POWER DISTRIBUTION LIMITS

PROOF & REVIEW COPY

3/4.2.3 RCS FLOW RATE AND NUCLEAR ENTHALPY RISE HOT CHANNEL FACTOR

FIGURE 1 RCS FLOW RATE VERSUS R

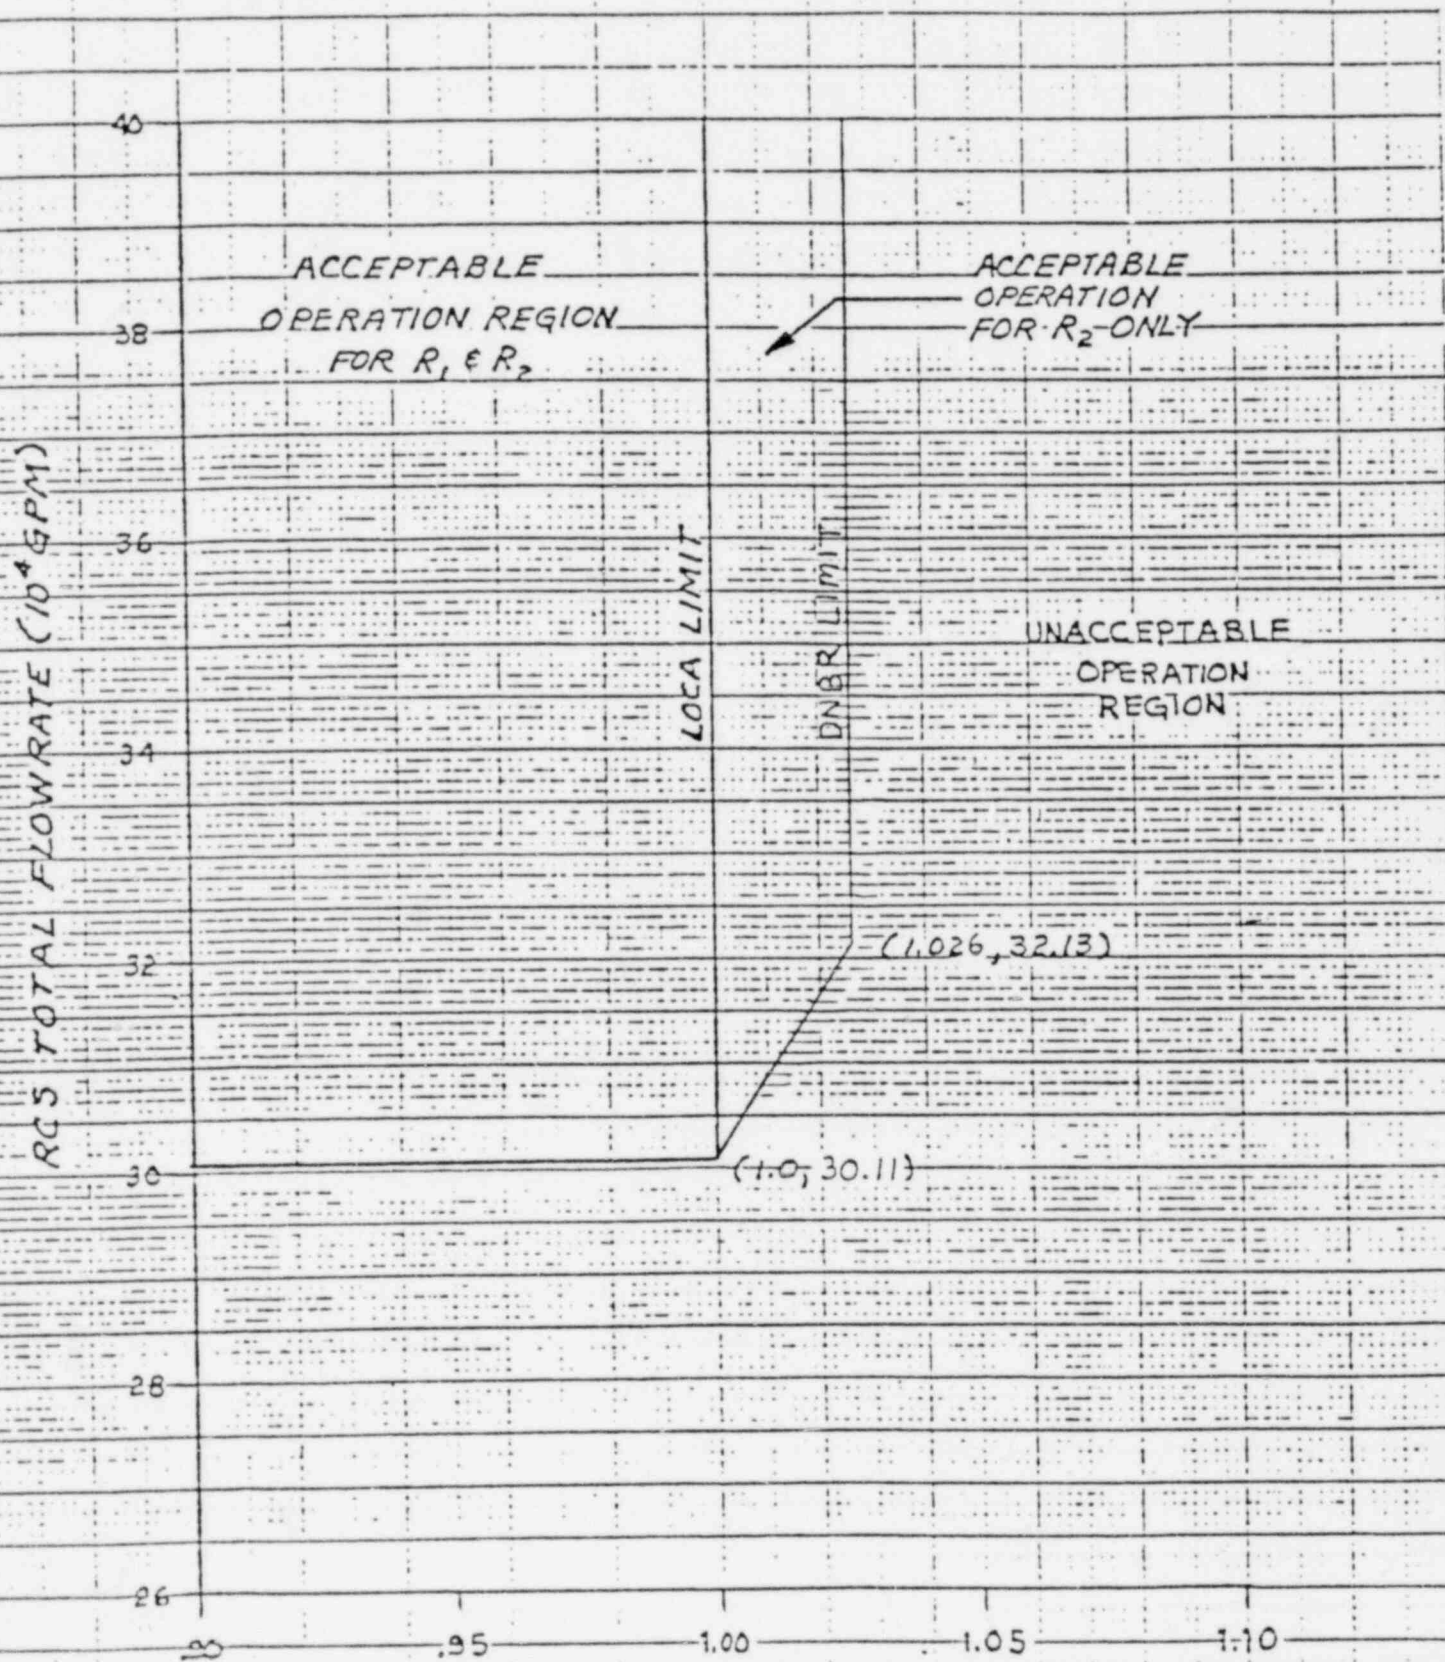
See New Figure Based on 2.4%
Measurement Uncertainties

MEASUREMENT UNCERTAINTIES
OF 1.75% FOR FLOW AND 4%
FOR IN-CORE MEASUREMENT
OF P_{12} H ARE INCLUDED IN
THIS FIGURE

THIS PAGE OPEN PENDING RECEIPT OF
INFORMATION FROM THE APPLICANT

MEASUREMENT UNCERTAINTIES OF 2.4% FOR FLOW
AND 4.0% FOR INCORE MEASUREMENT OF F_{2H}^N INCLUDED

$$R_1 = F_{2H}^N / 1.49 [1.0 \pm 0.2(1.0 - P)]$$

$$R_2 = R_1 / [1.0 - RBP(BU)]$$
